In The Matter Darfield Plan Change 63

OFFICER COMMENTS OF MURRAY ENGLAND

Appendix 1

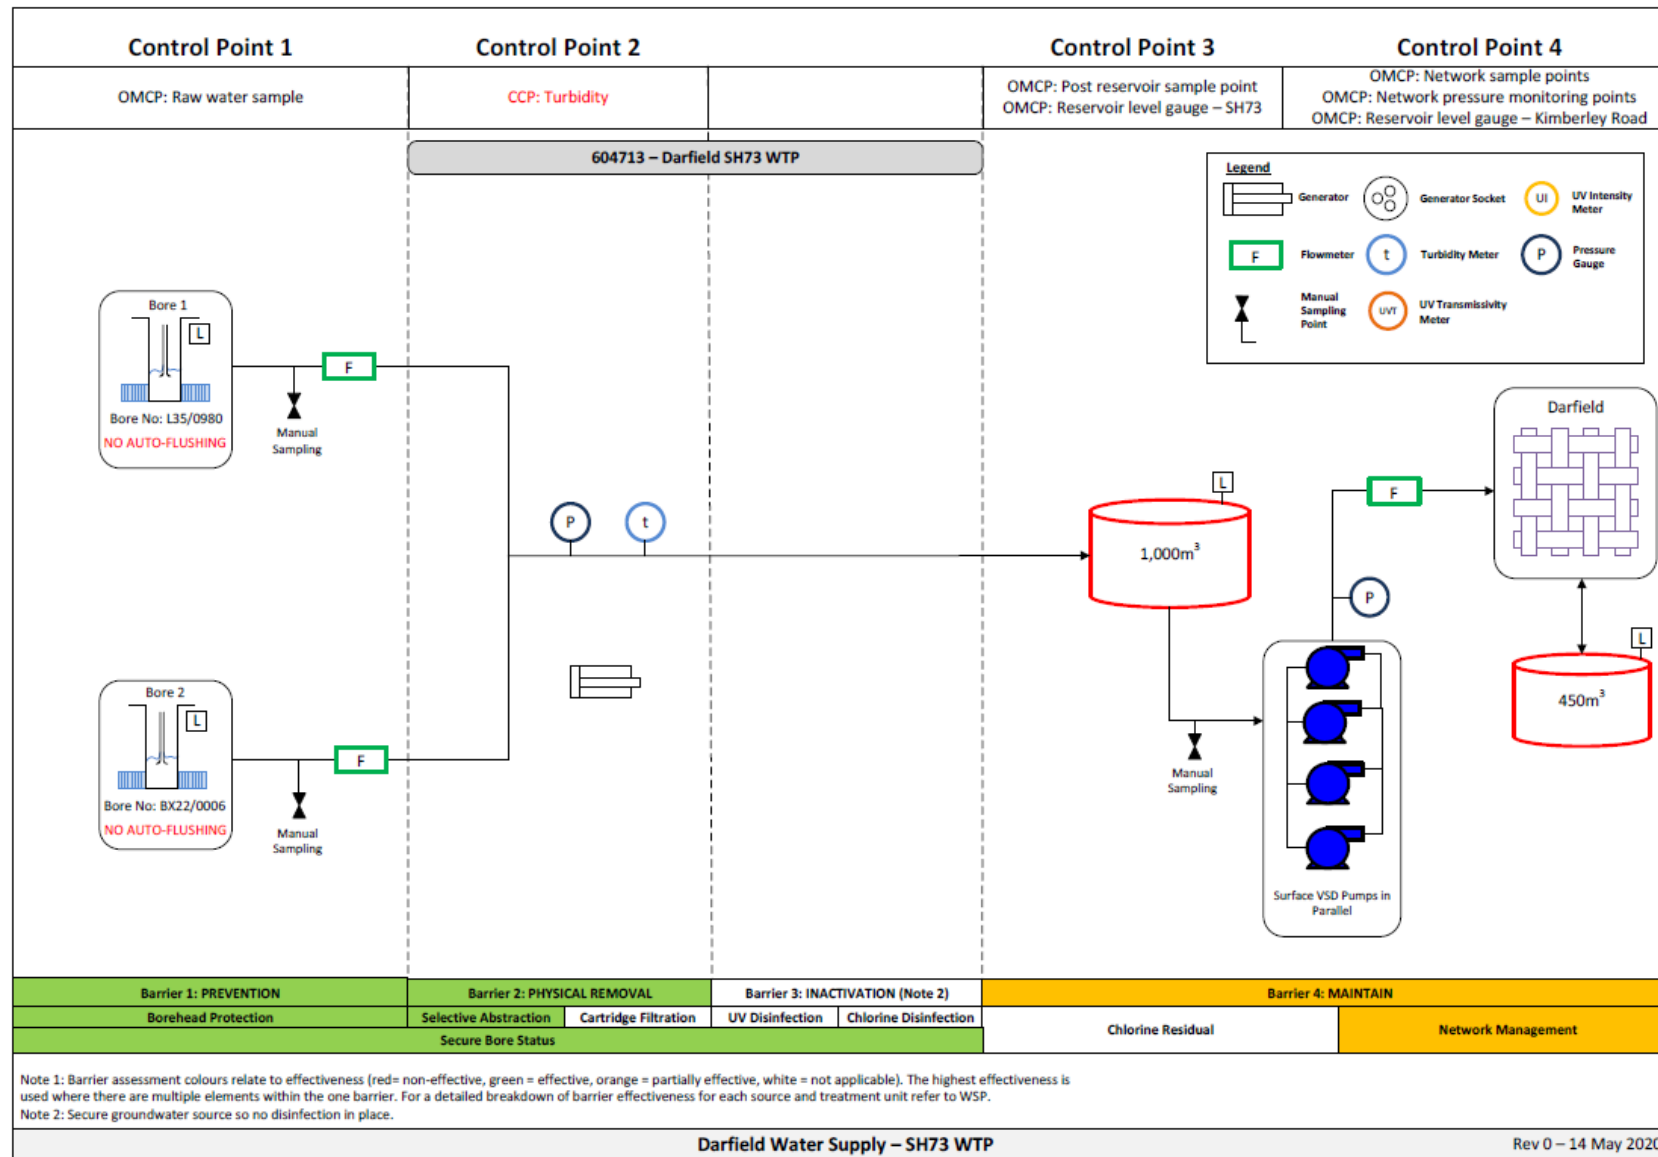
6. The Darfield Water Supply provides untreated secure groundwater to the Darfield community from bores L35/0980 and BX22/0006. These bores supply water to the network via a reservoir and booster pump station (**Refer Appendix 1 and 2**) .
